Vested Right Claim
~~WATER PERMIT~~ NO. 1461-1

VESTED RIGHT WATER LICENSE NO. 1461-1

This letter is in response to a vested right claim being made for Martian dam located in Corson County, South Dakota. The following information is needed concerning the dam to complete the vested right claim:

Review of Contents of Plans & Specifications

SECTION A' APPROACH CHANNEL
NTS

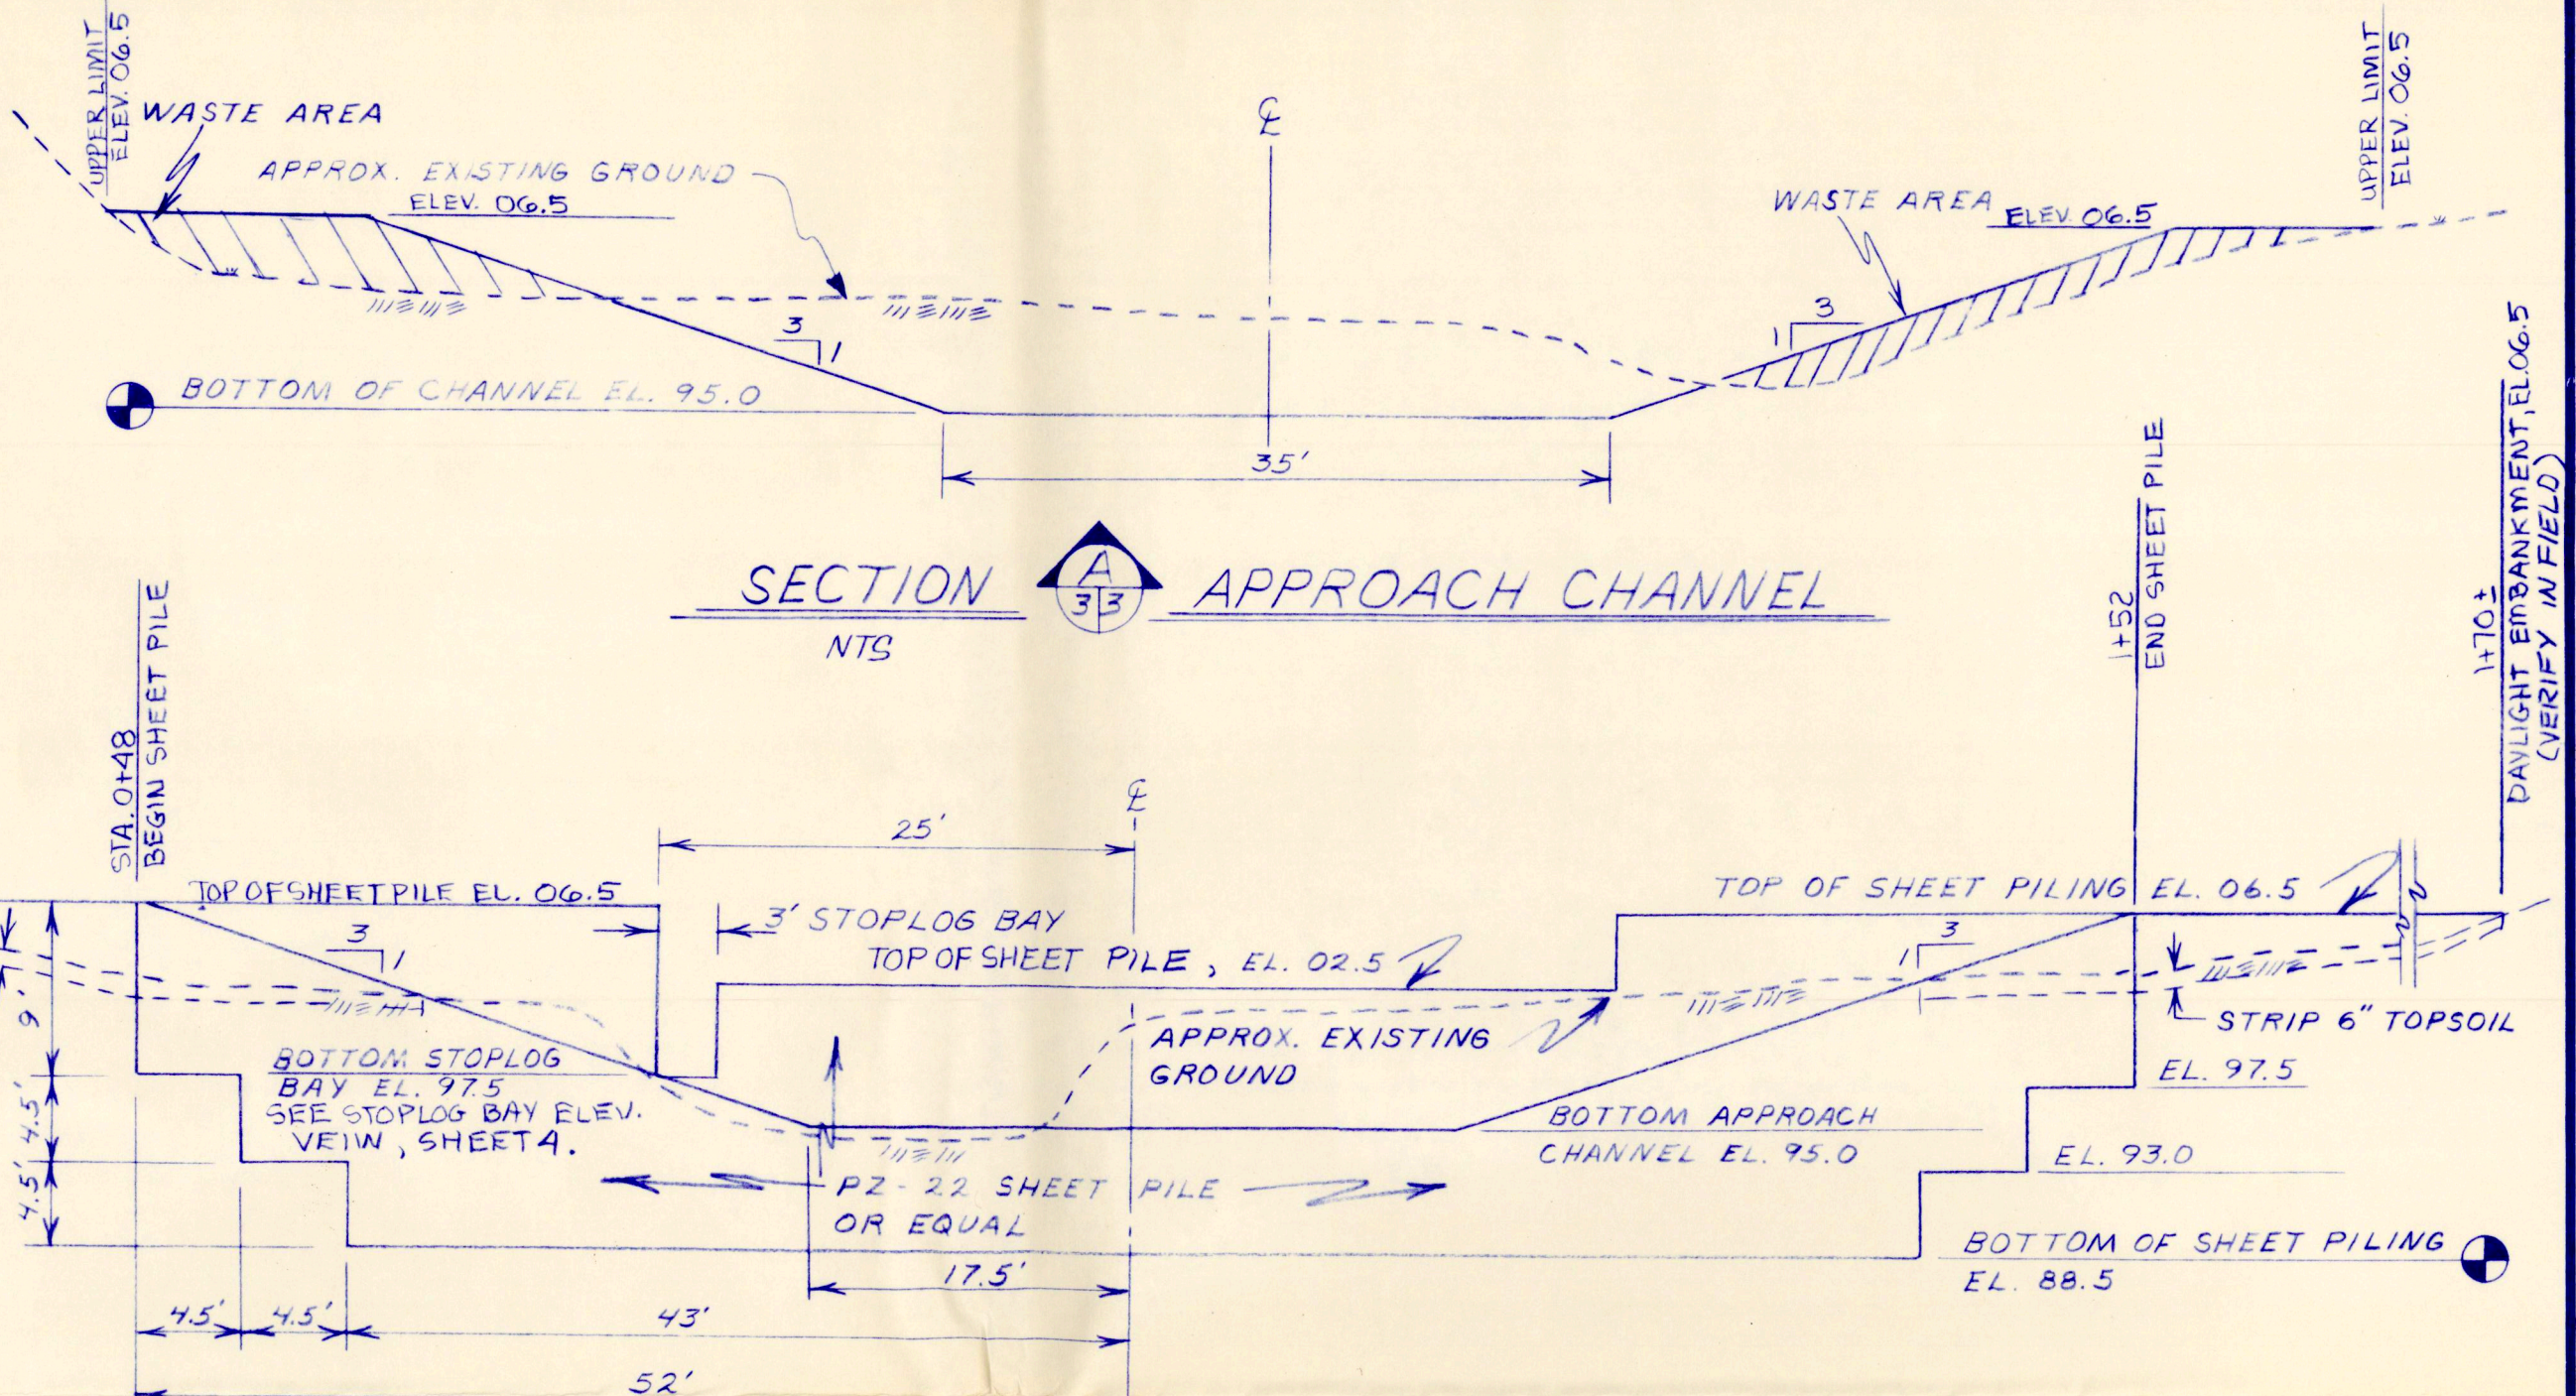
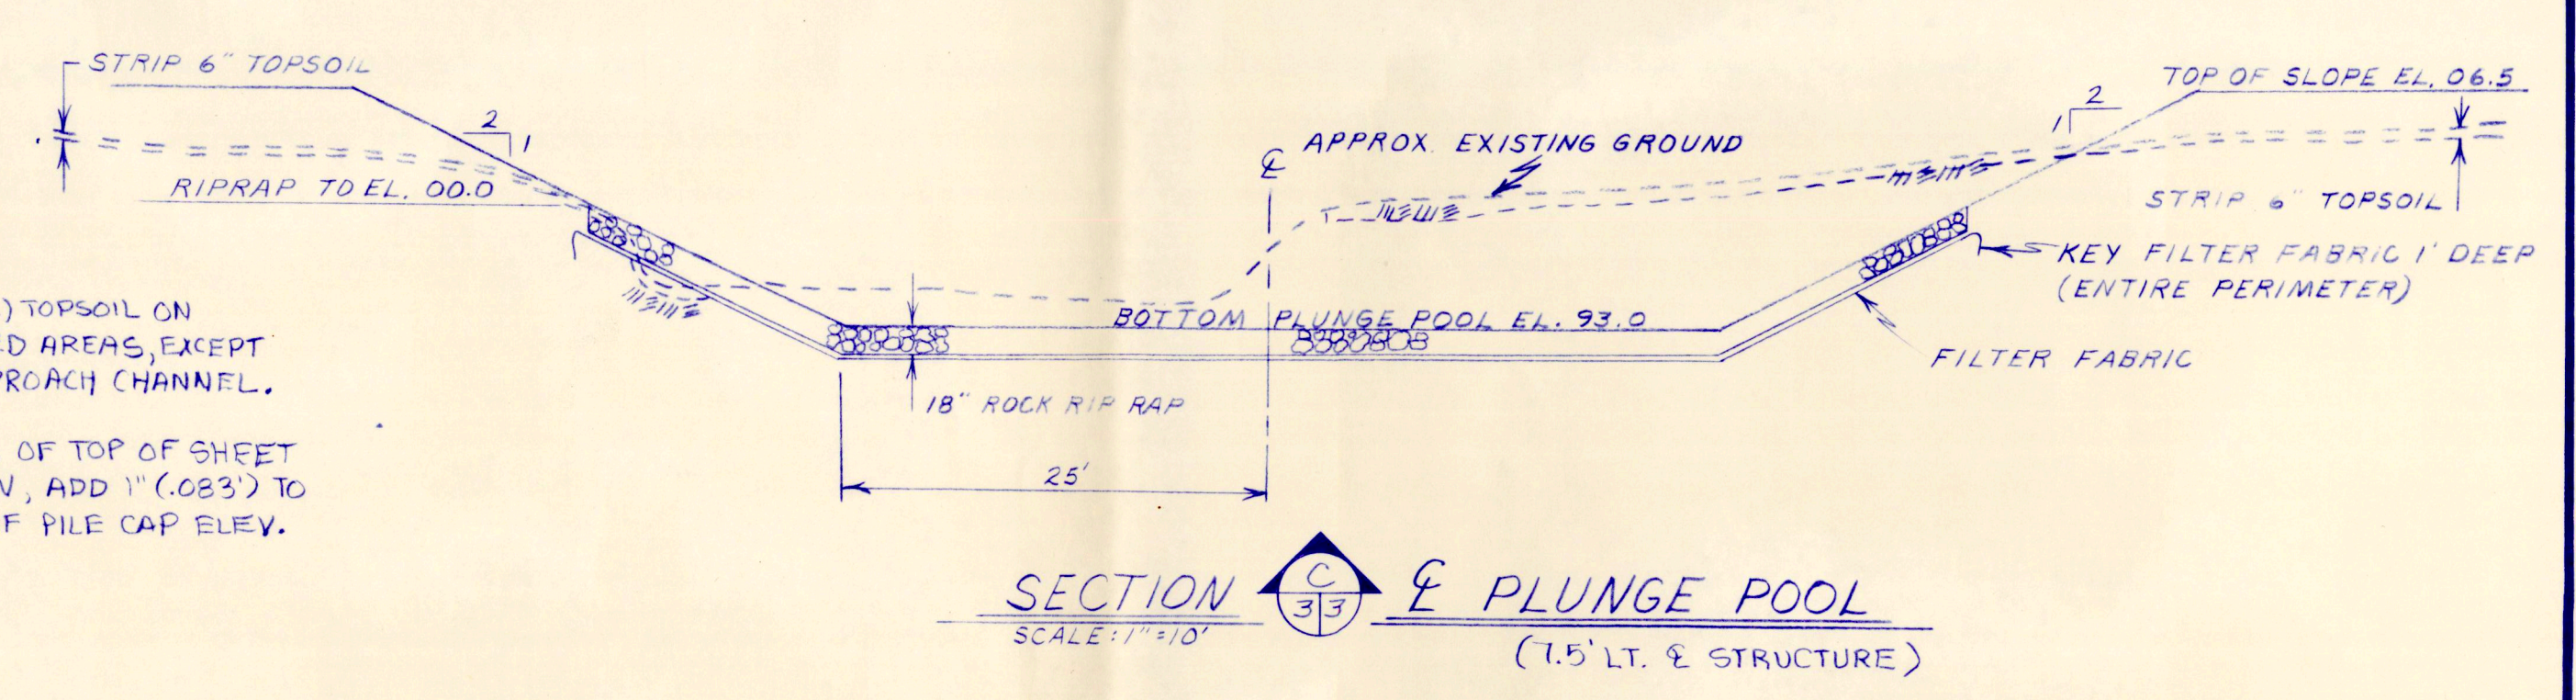
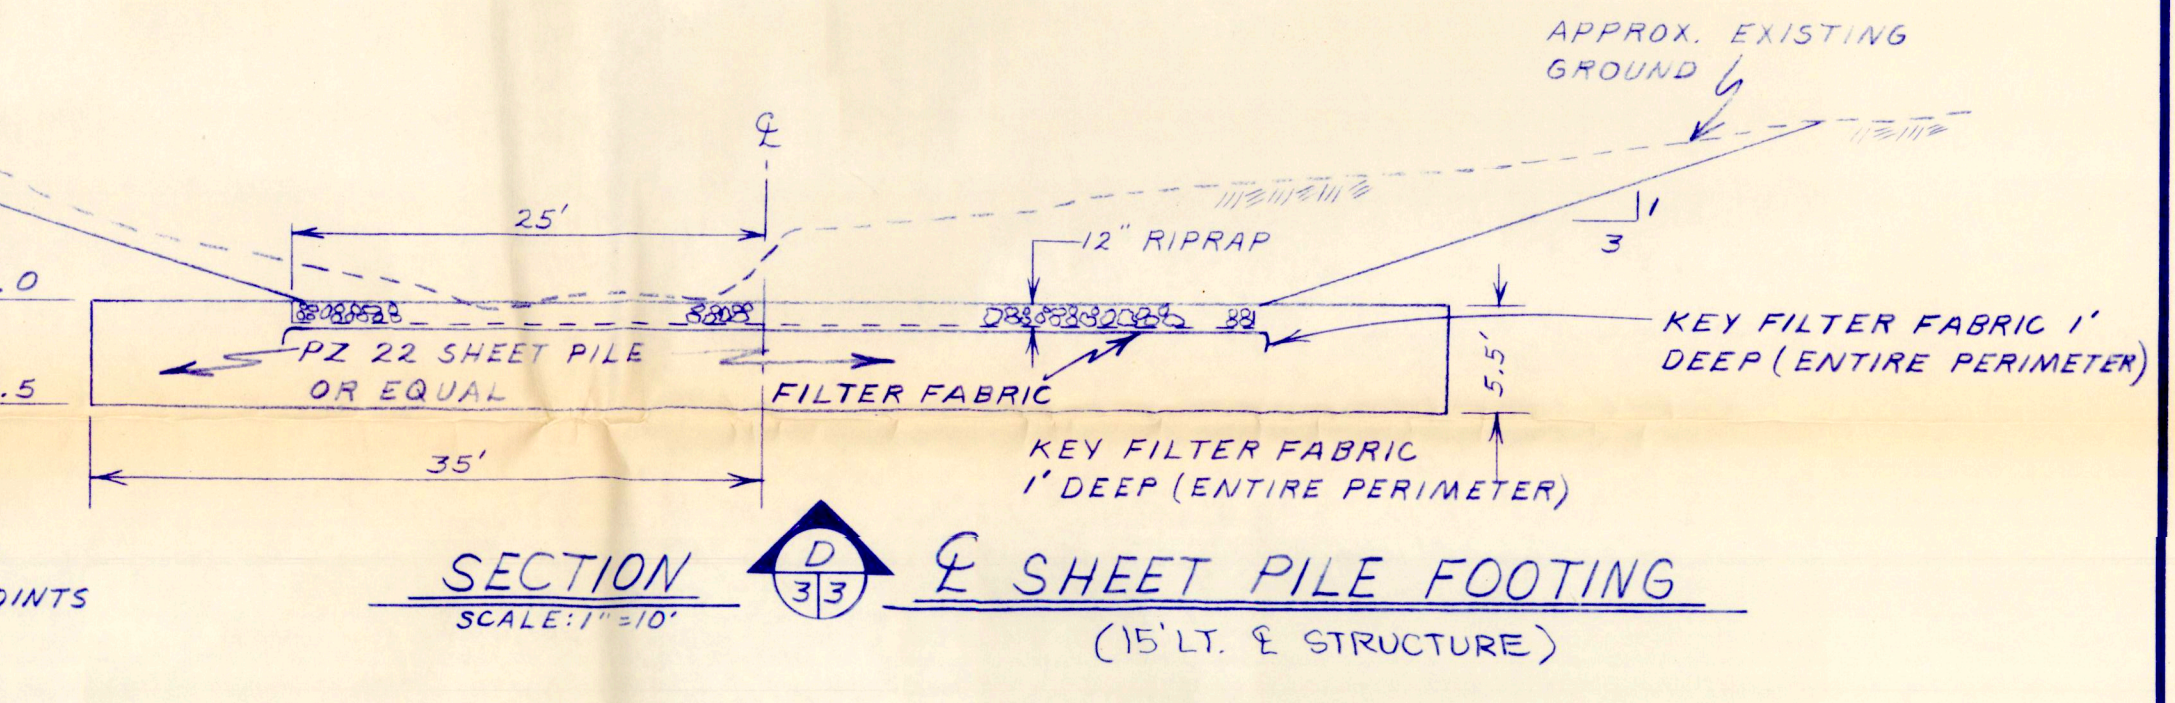
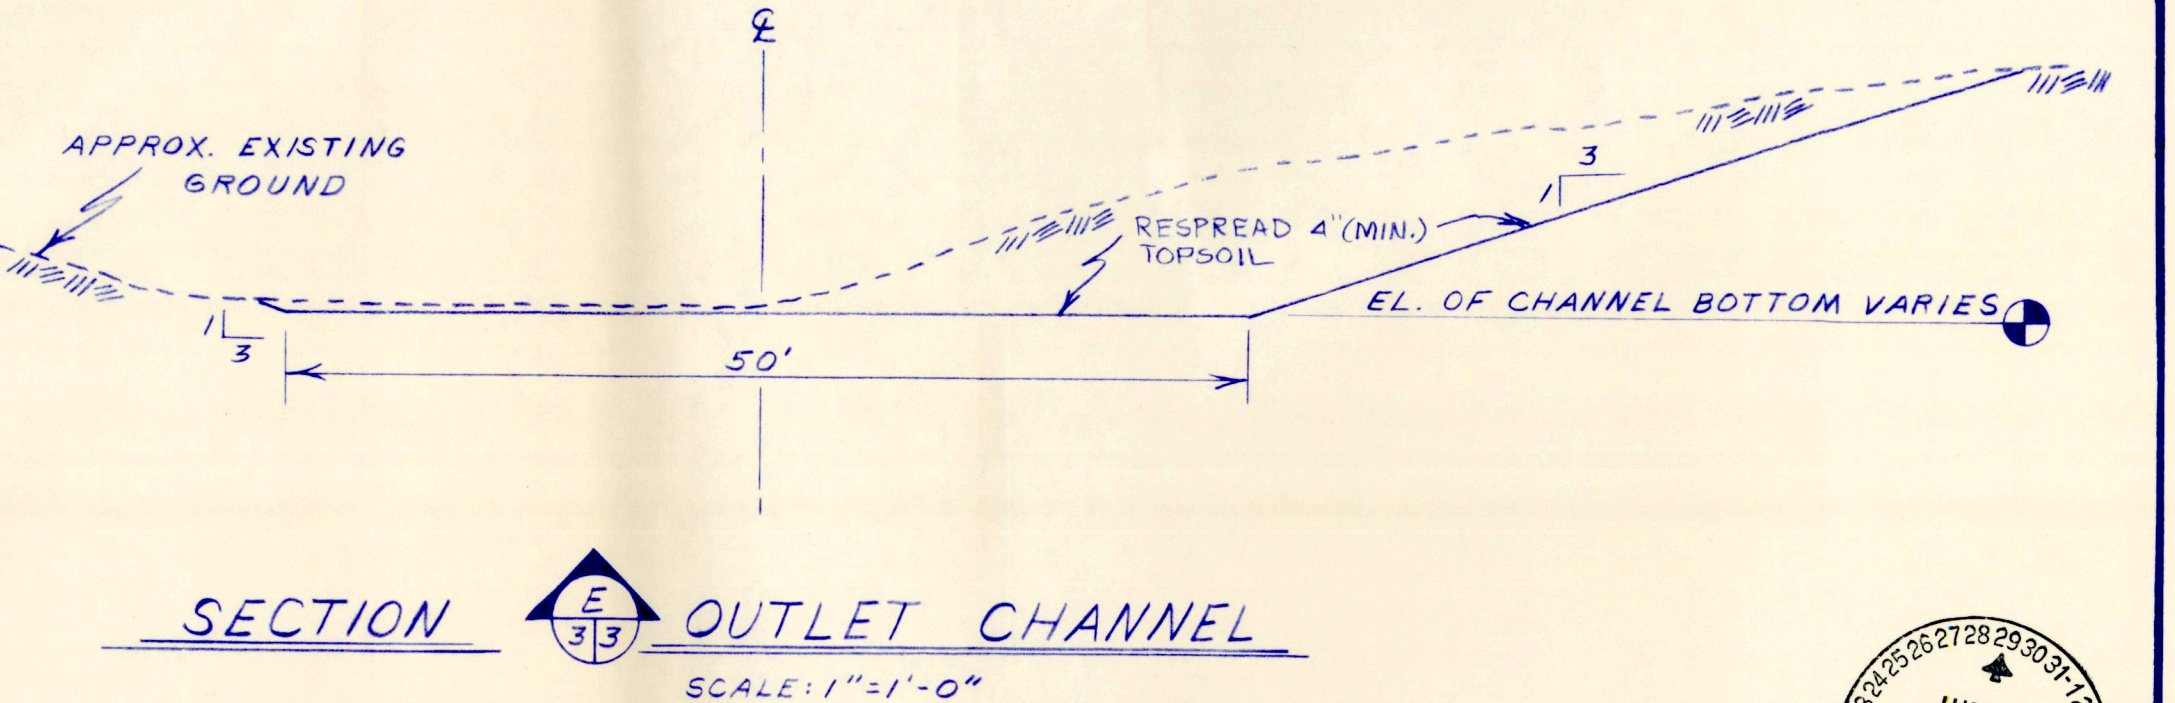
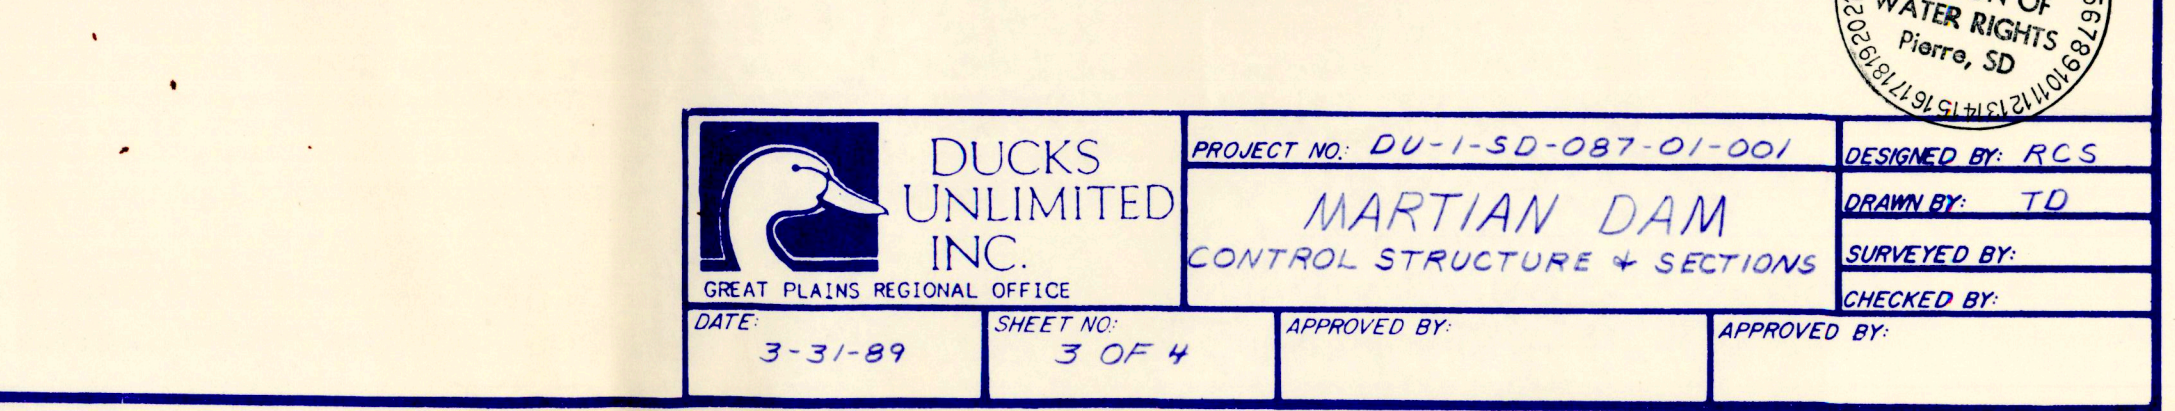
- 1) The enclosed plans and specifications need to be signed and stamped by a South Dakota registered professional engineer.
- 2) A written preliminary risk assessment of the downstream hazard potential needs to be provided to aid in determining the hazard classification for the dam (see enclosed Safety of Dams Rules Section 74:02:08:05). The hazard classification of the dam (Category 1, 2 or 3) is needed to determine what provisions of the Safety of Dams Rules will apply to your dam.

- 1) Topo map submitted? yes
- 2) Profile along dam axis & borehole locations? yes
- 3) Maximum cross section of dam? yes
- 4) Area - Capacity curves? yes but could be extended
- 5) Detailed drawings? yes
- 6) Q capacity of spillway? yes
- 7) Detailed plans of spillway? yes
- 8) Specifications? yes
- 9) EPP? not needed as determined from preliminary risk assessment

- 1) Construction plans and specifications signed by myself, a professional engineer registered in South Dakota.
- 2) A preliminary risk assessment.
- 3) A Design Report.
